OFFSHORE OPERATORS COMMITTEE

**RE: Offshore Operators Committee Comments  
Notice of Proposed National Pollutant Discharge Elimination System (NPDES)  
General Permit for New and Existing Sources in the Offshore Subcategory of the  
Oil and Gas Extraction Category for the Eastern Portion of the Outer Continental  
Shelf (OCS) of the Gulf of Mexico (GEG460000), Public Notice No. 16AL00001.**

## Draft NPDES General Permit for New and Existing Sources in the Offshore Subcategory of the Oil and Gas Extraction Category for the Eastern Portion of the Outer Continental Shelf of the Gulf of Mexico (GEG460000)

### GEG460000 August 18, 2016 Draft Renewal Permit, Public Notice No. 16 AL00001 – Offshore Operators Committee Comments

**ATTACHMENT A**  
**COMMENT NO. 4**

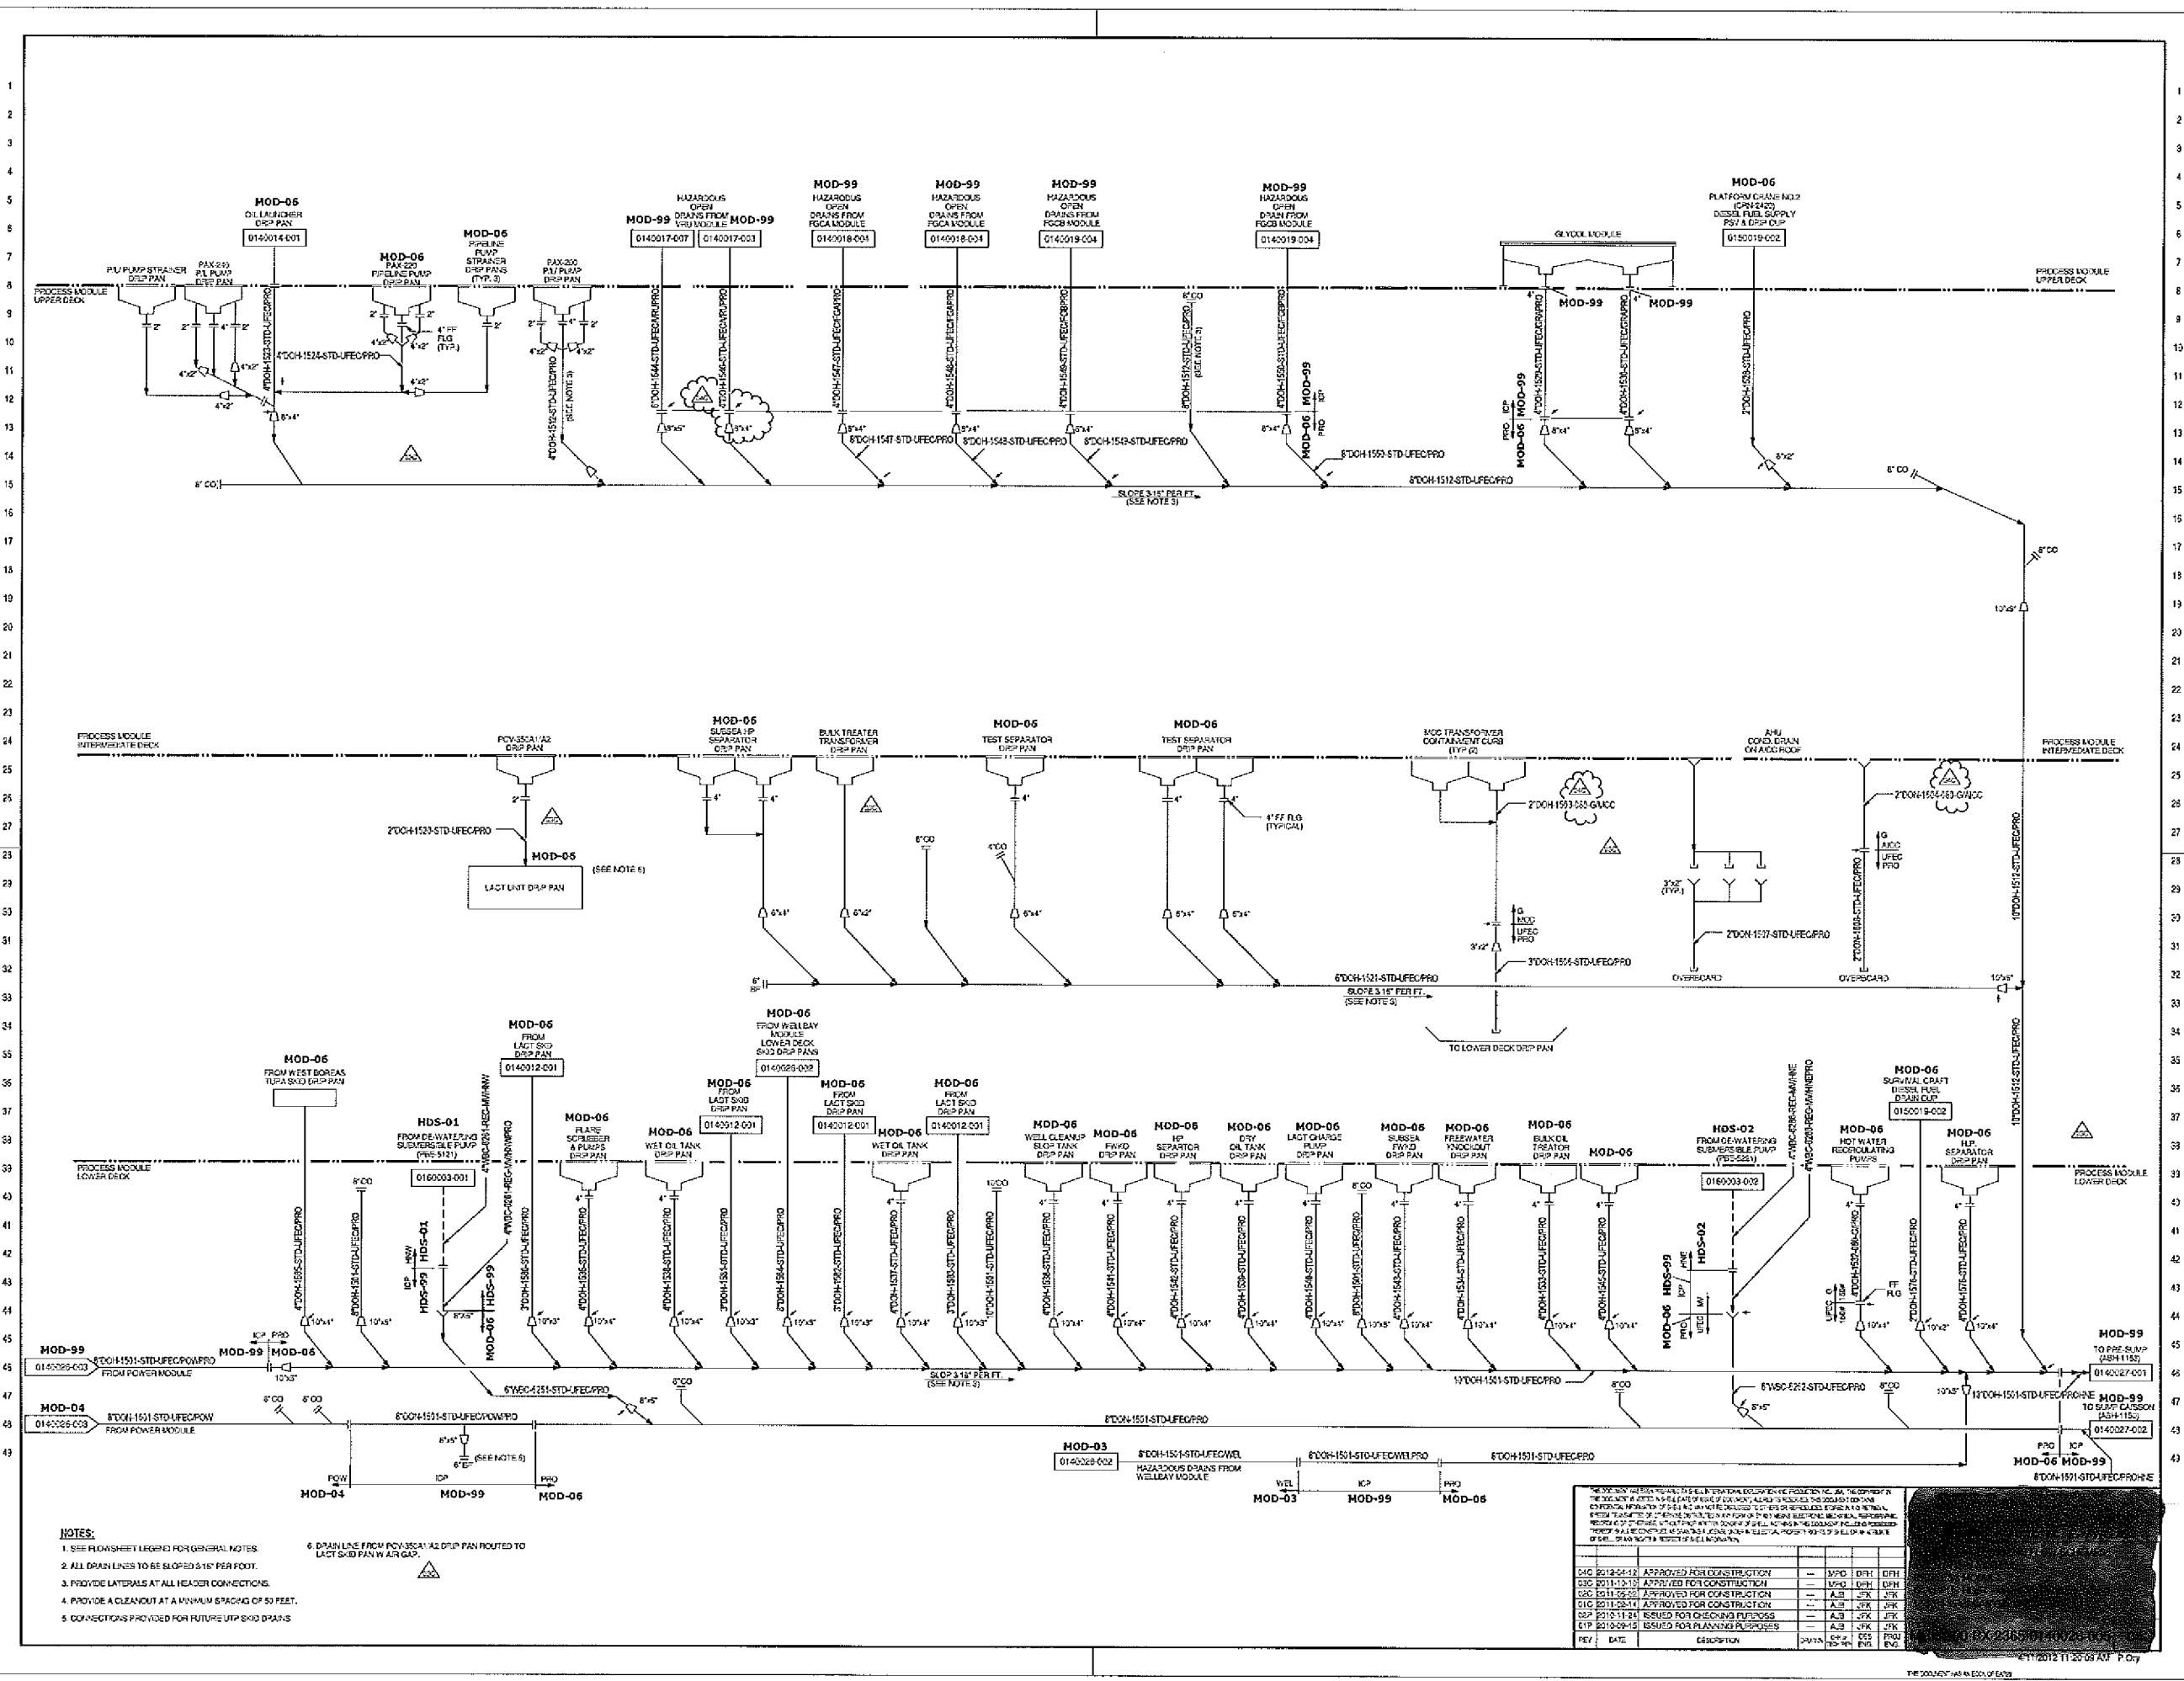
Example drain system isometric drawing for offshore platform- vertical pipe stubs connect to collection systems (e.g. skid pans). Effluents are collected and routed to presumpt and/or sump pile emergency sump (not shown on diagram- see example flow diagrams)
